BOARD OF COMMISSIONERS

AGENDA

Monday, January 12, 2015 - 6:30 PM

RE: 145 King of Prussia Road
Preliminary Land Development Plan
Review No. 1
RETTTEW Project No. 101442004

**COVER SHEET
FOR**

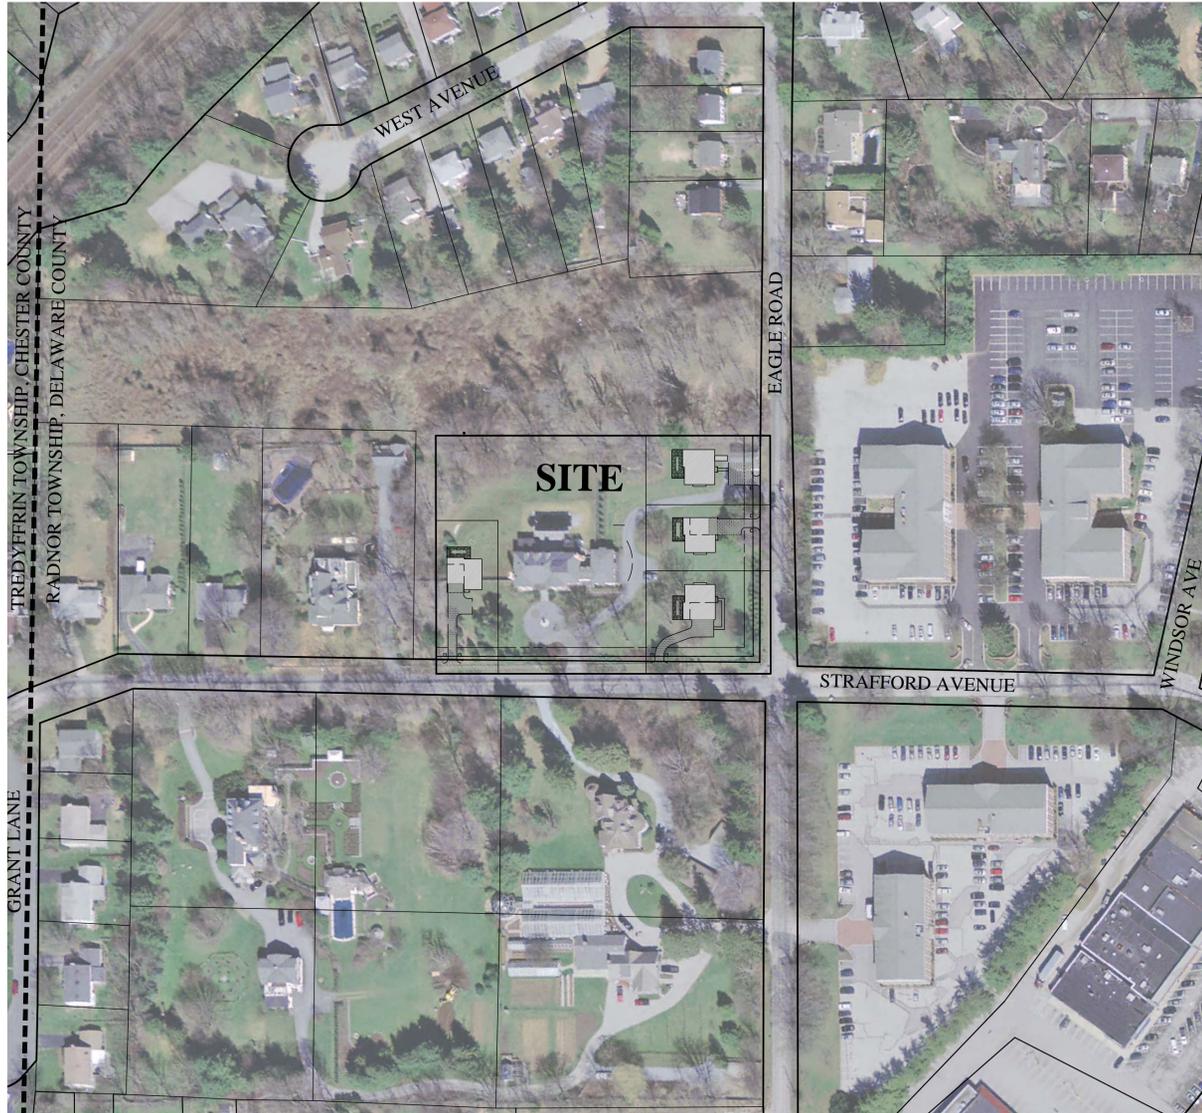
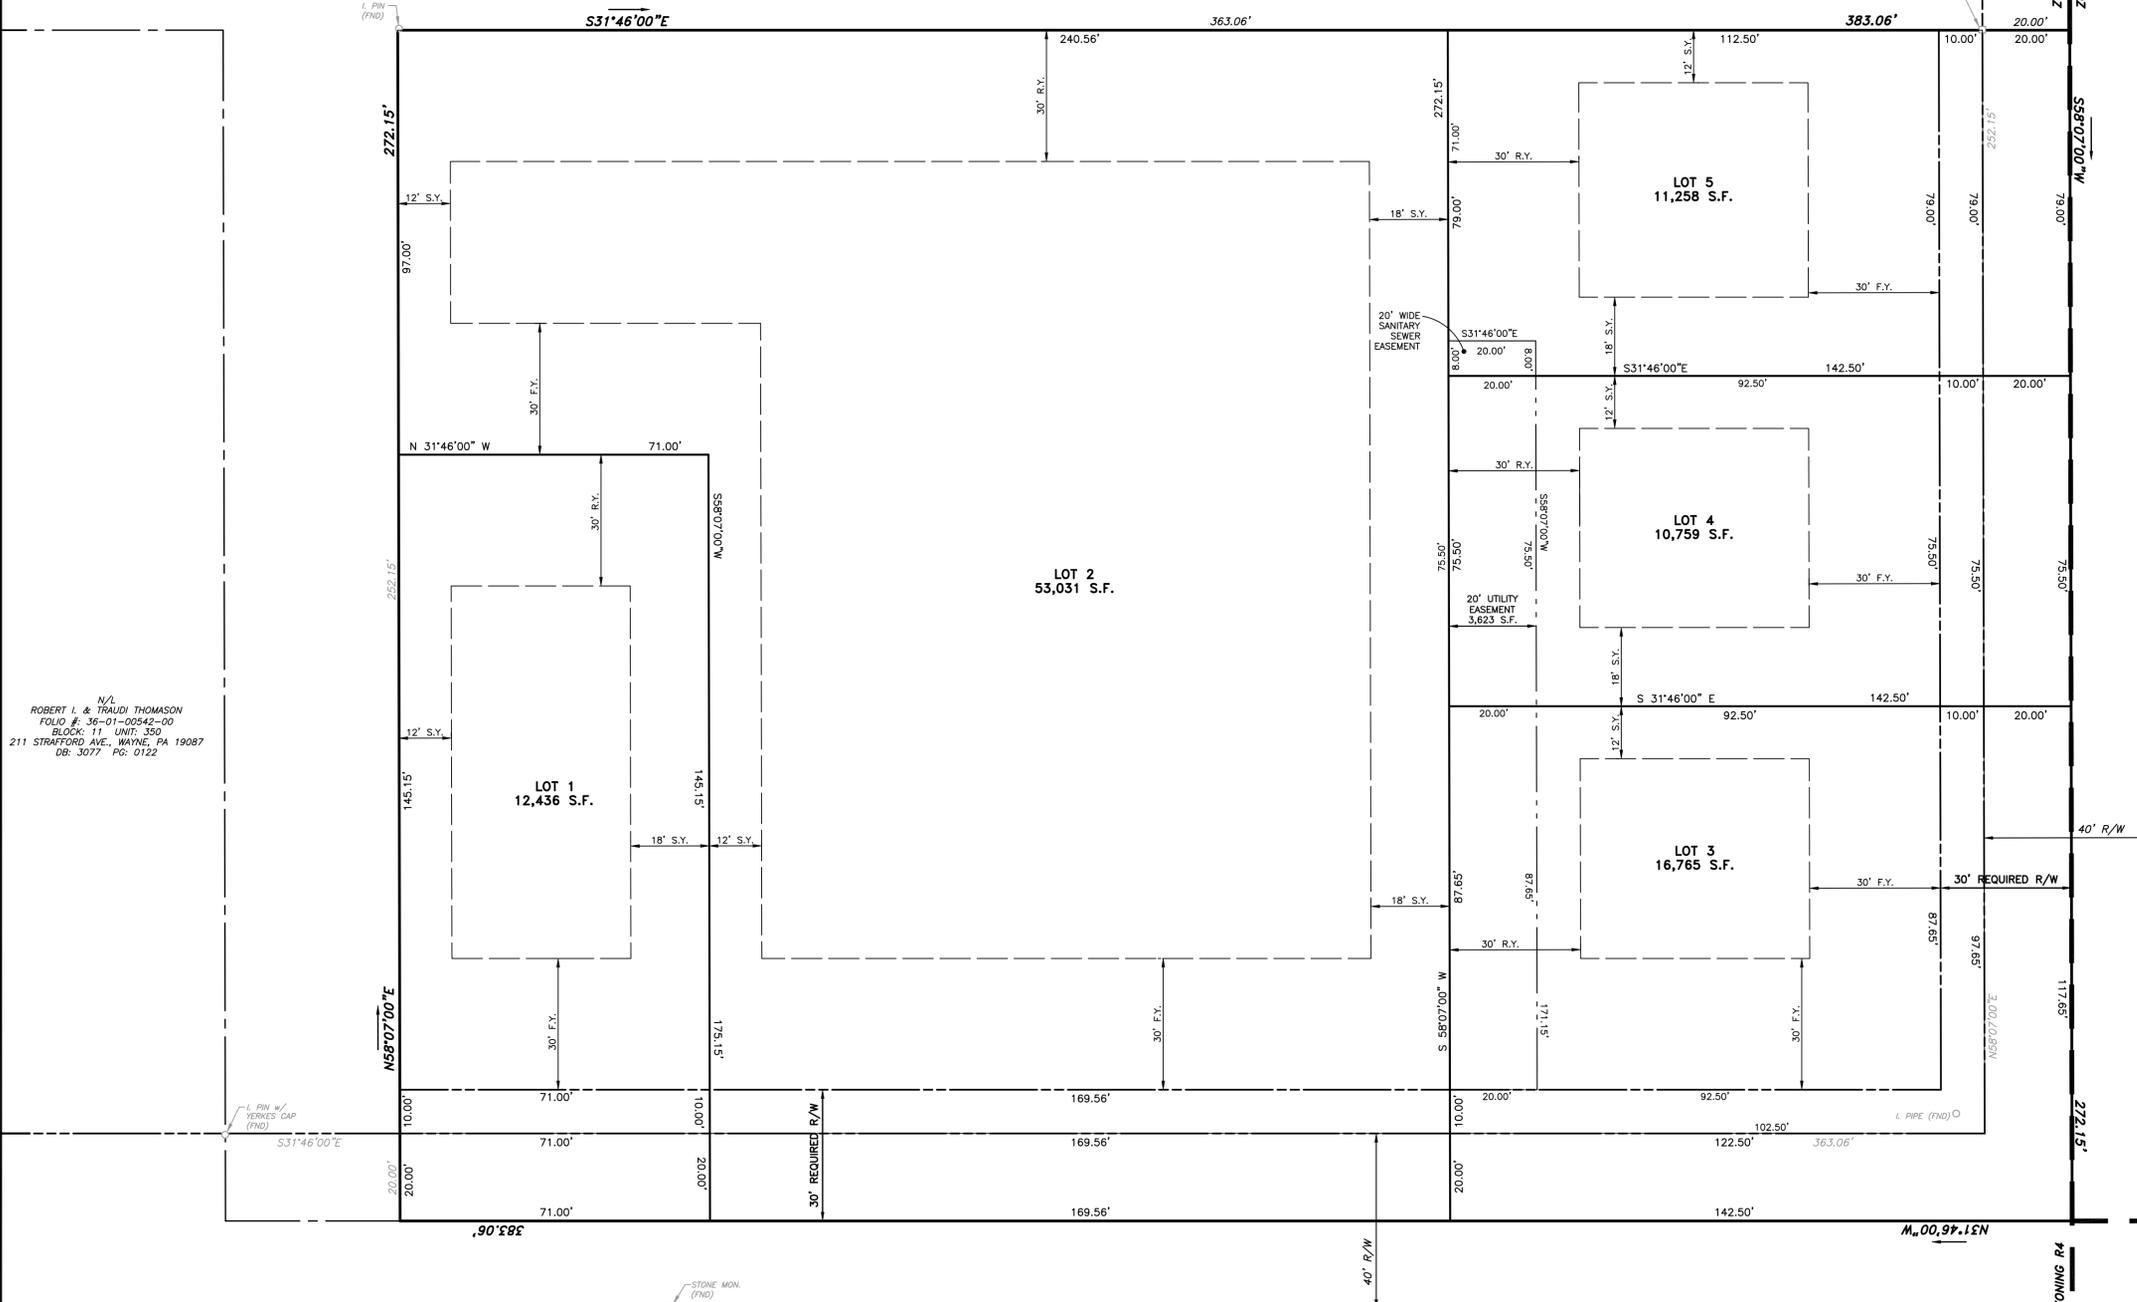
5. Modify the plan Legend to include a symbol for identifying sidewalks on the plan.
6. Revise Note 13 on Sheet 1 to indicate that during construction, no lane closures shall occur from 6AM-9AM and 3PM-6PM weekdays without approval by the Radnor Township Public Works Director.
7. The applicant must complete PennDOT TE-672 *Pedestrian Accommodation at Intersections Checklist* form in support of not providing pedestrian crosswalks and curb cuts at the intersection of Eagle Road and Strafford Avenue.
8. The applicant has acknowledged the need for an access easement and maintenance agreement for the Lots 3, 4 and 5 shared access driveway to Strafford Avenue.

- D. On Sheet 1, the north arrow orientation between the site map and location is inconsistent. Revise as needed.
- E. An access easement and maintenance agreement is required between Lot 1 and Lot 2 for the shared driveway. Another access easement and maintenance agreement is required for Lots 4, 5, and 6 for the shared driveway. Access easements are depicted on Sheet 2.

FINAL MINOR SUBDIVISION PLAN

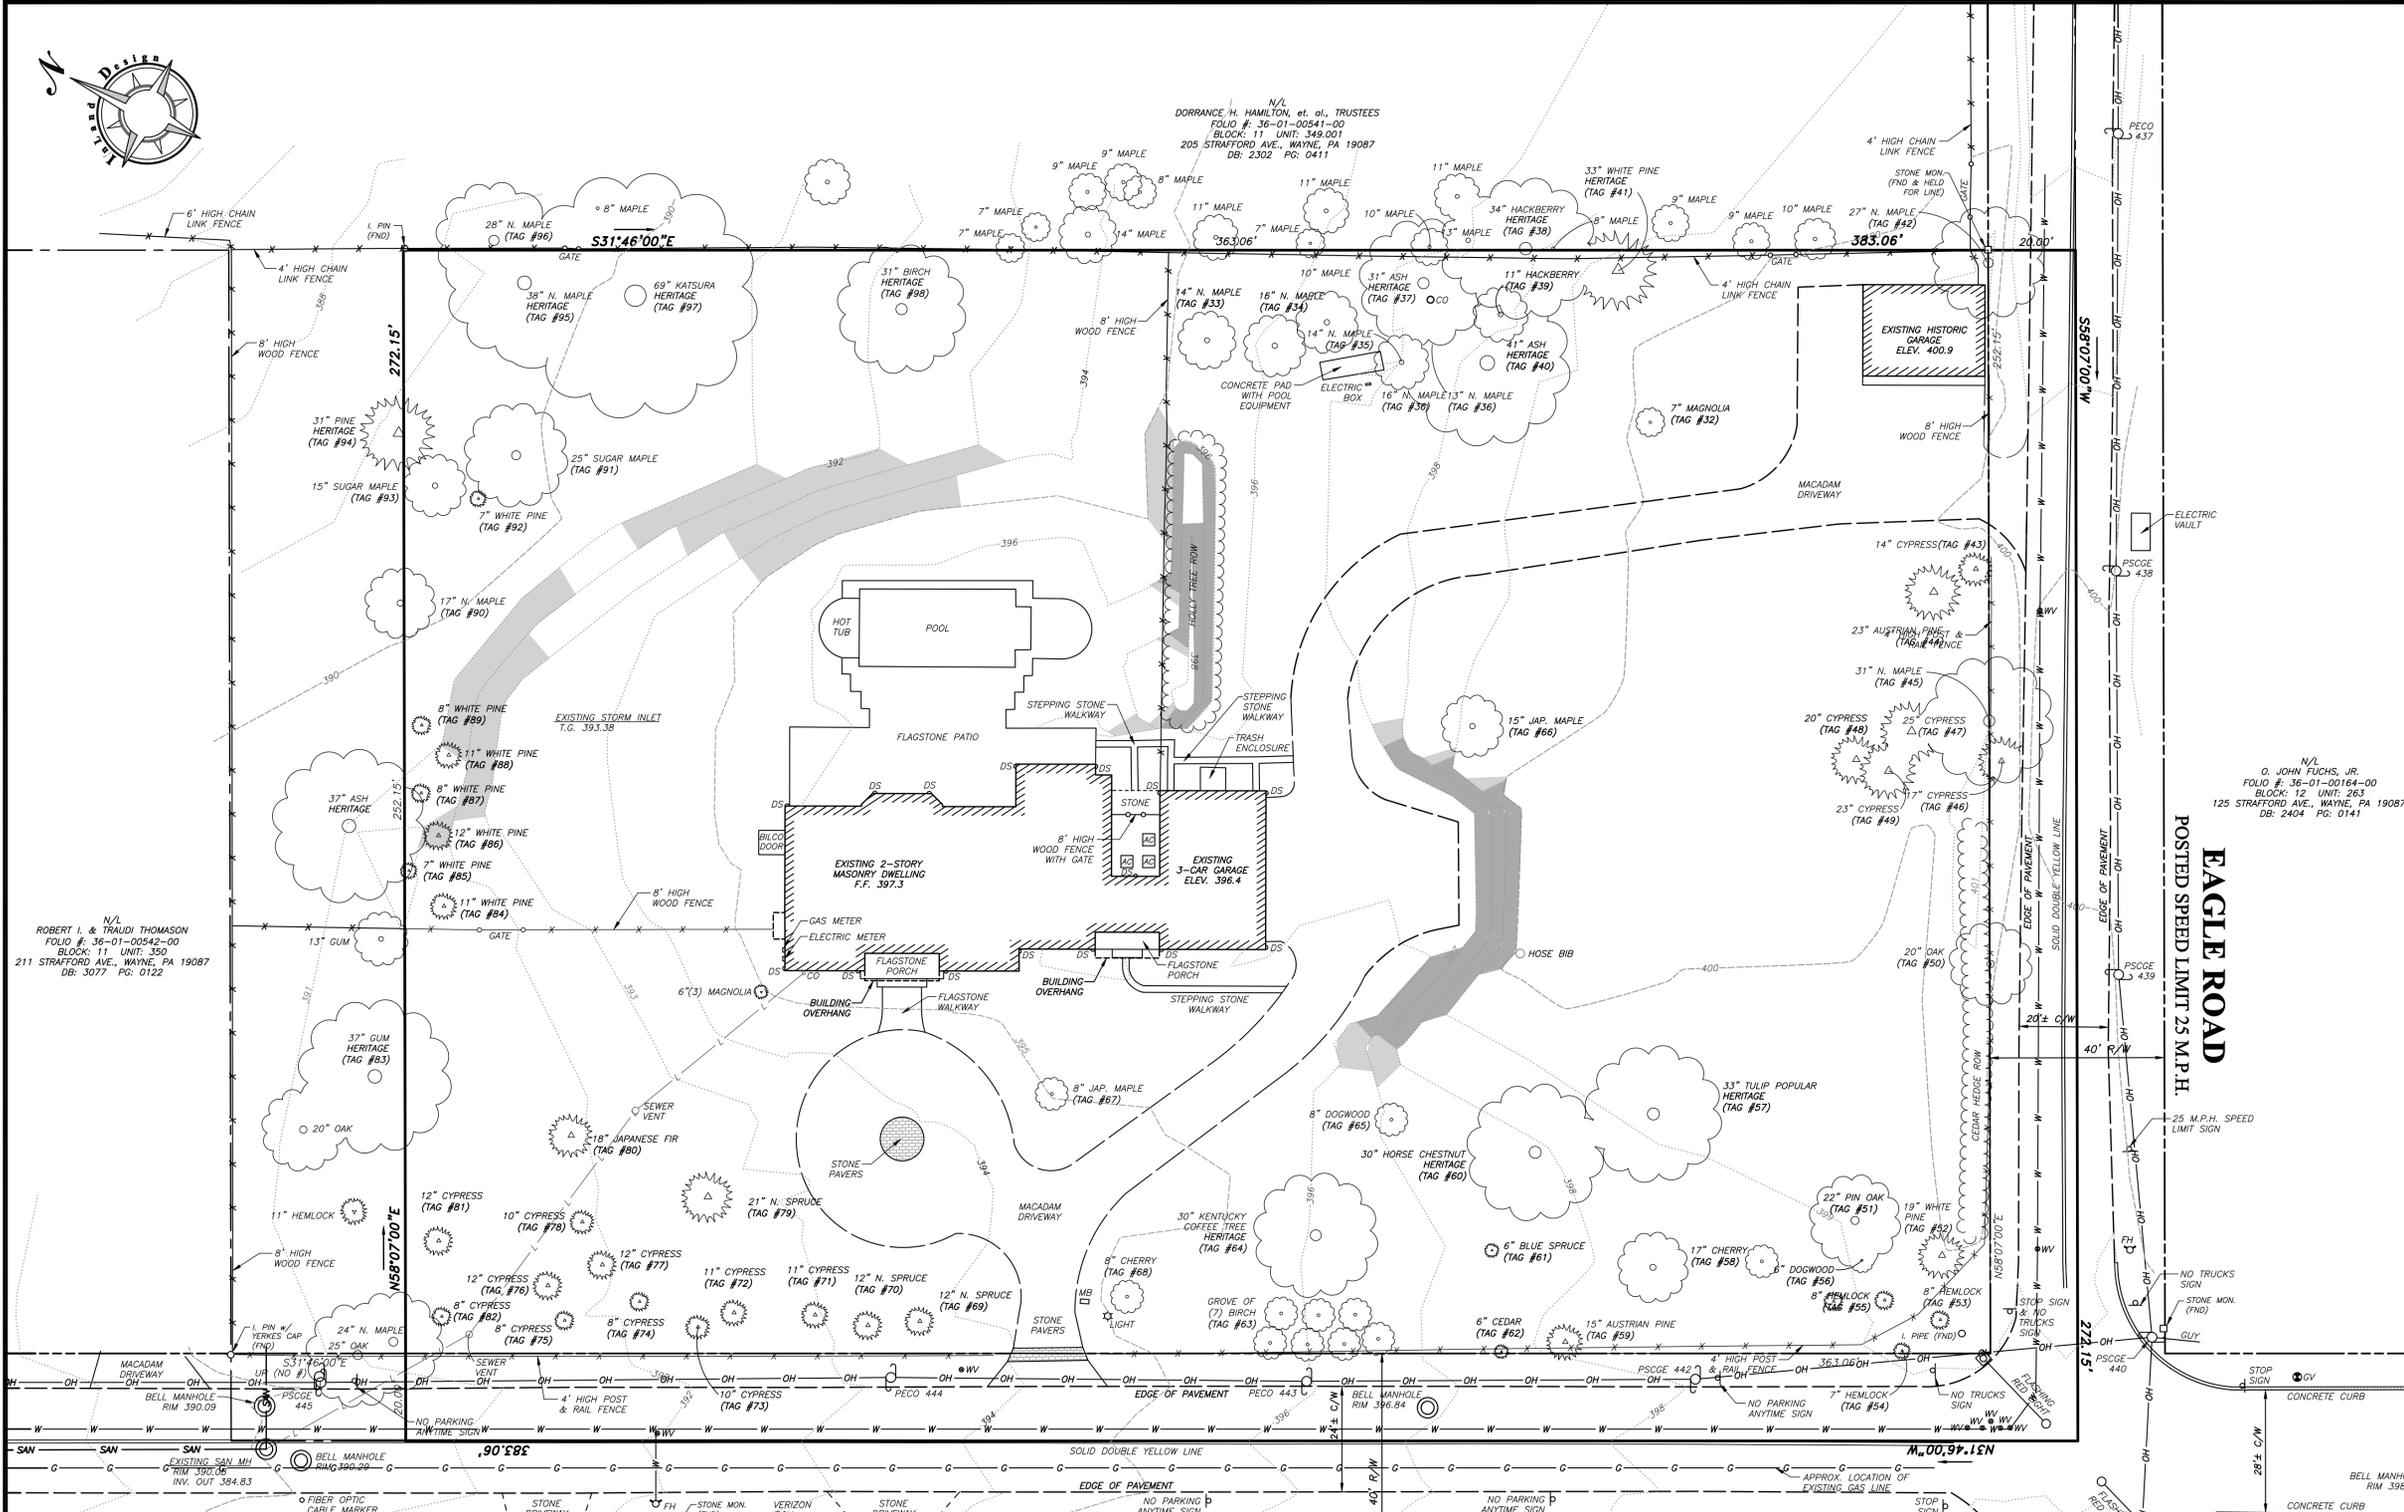
1. The applicant has indicated that the common driveway will be maintained by the Homeowners Association and documents will be provided for review.
2. The utility plan on sheet 5 indicates existing sanitary manhole 1 and proposed sanitary manholes 2 and 4. The sanitary sewer profile on sheet 10 indicates existing manhole 1 and proposed manholes 2, 3 and 4. This must be revised to be consistent.
3. The water line should be shown on the profile view when it crosses that sanitary sewer line. This is missing from the profile view between proposed manholes 2 and 3.
